ON-SITE SEWAGE DISPOSAL SYSTEM
HOWARD COUNTY HEALTH DEPARTMENT
BUREAU OF ENVIRONMENTAL HEALTH

SUBDIVISION: Fox Creek LOT NUMBER: ~~1~~ 3

ADDRESS: 12305 Fox Meadow Lane PROPERTY OWNER: NVR., Inc.

WALL CHECK
 LOT 3
FOX CREEK SUBDIVISION

Approved Septic System Plan
 FOX MEADOW LANE
 EX. PUBLIC ACCESS STREET
 HOWARD COUNTY HEALTH DEPARTMENT
 R/W 24' PAV.

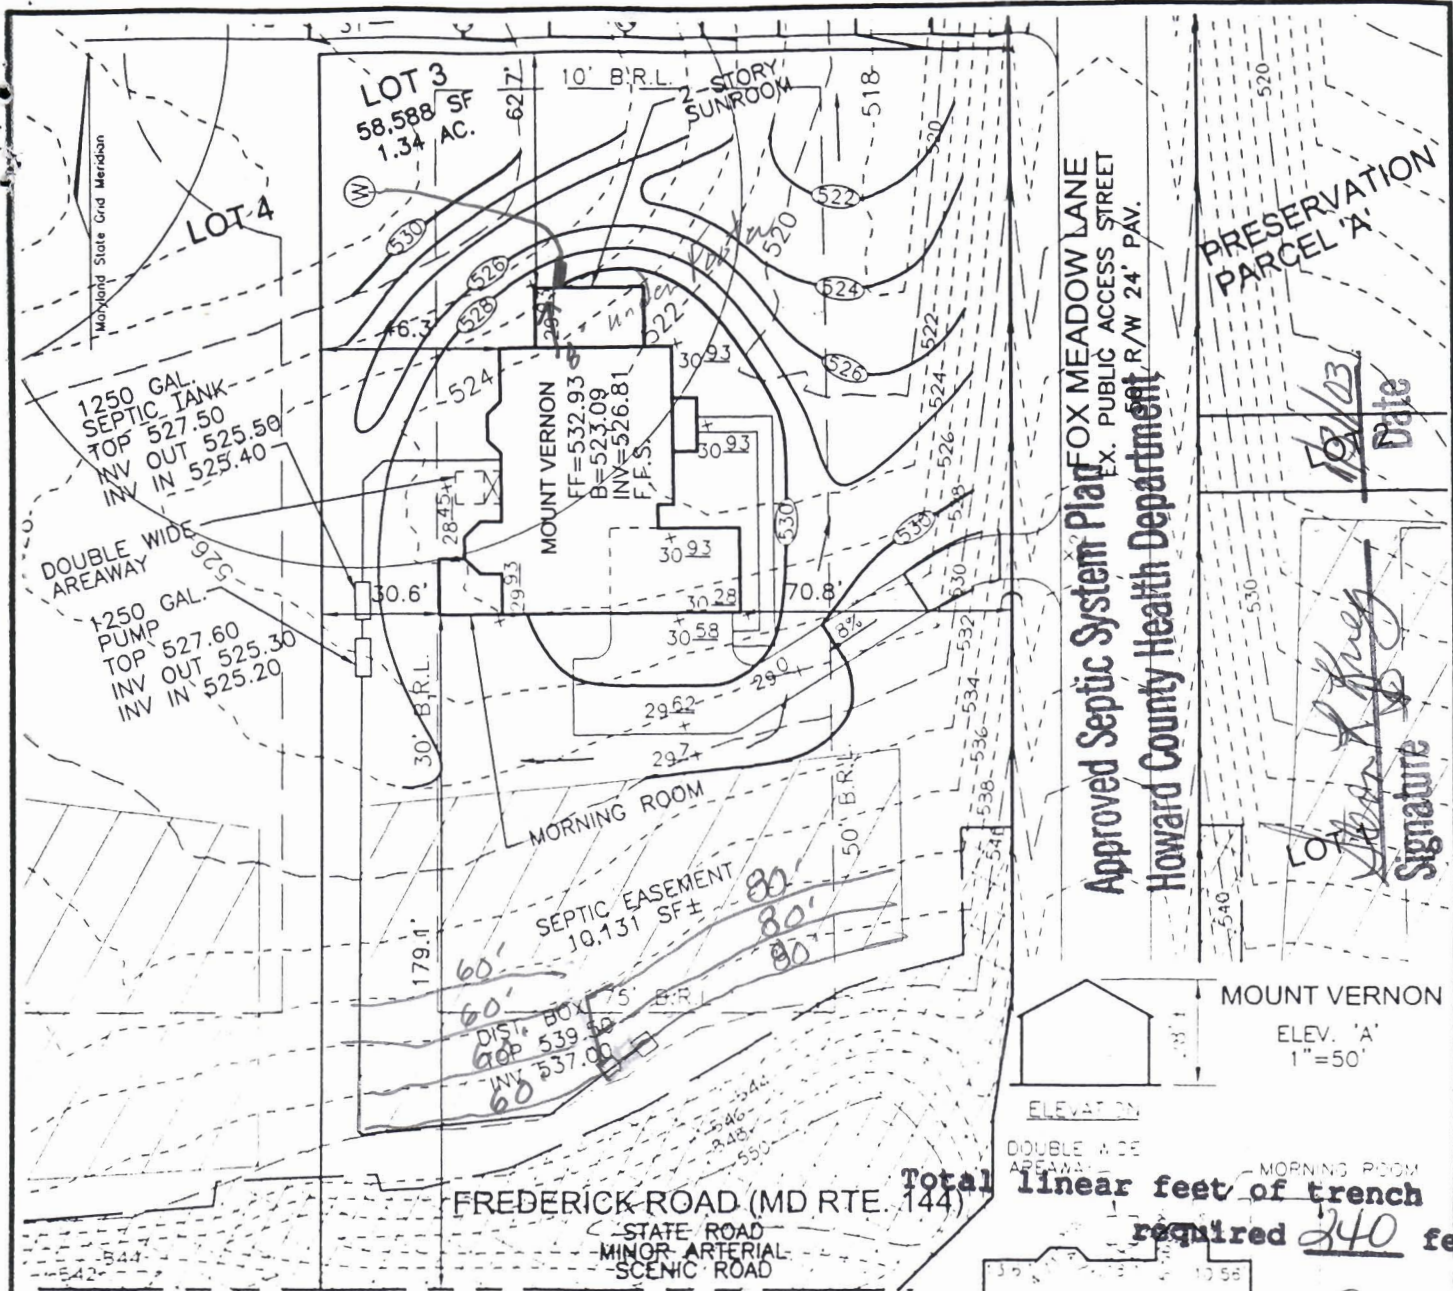
PRE-CONSTRUCTION 11/17/03 Distribution box to be placed at top of easement to allow installation of three 80' trenches for first installation system. Repair will be 4-60' trenches in opposite direction. Keep the tanks out of the center of the swale. (BB)

11/21/03 - OK to cover all work. Pump & Alarm tests needed SO 12/30/03 Pump + Alarm test OK (KB/50)

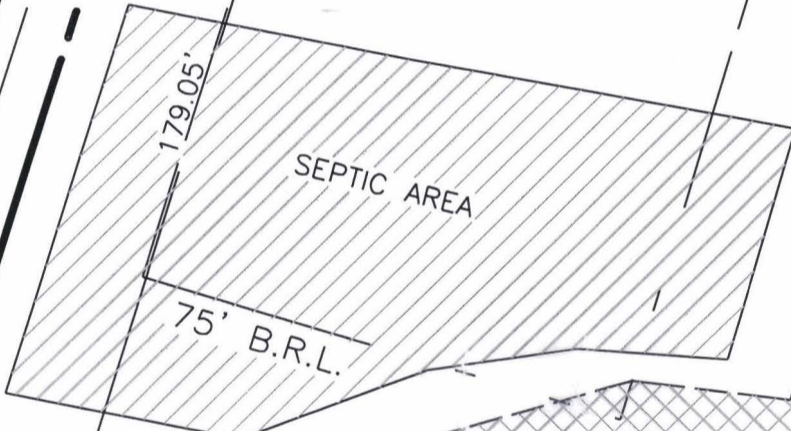
10/29/03-
Wall Check
OK (SRK)
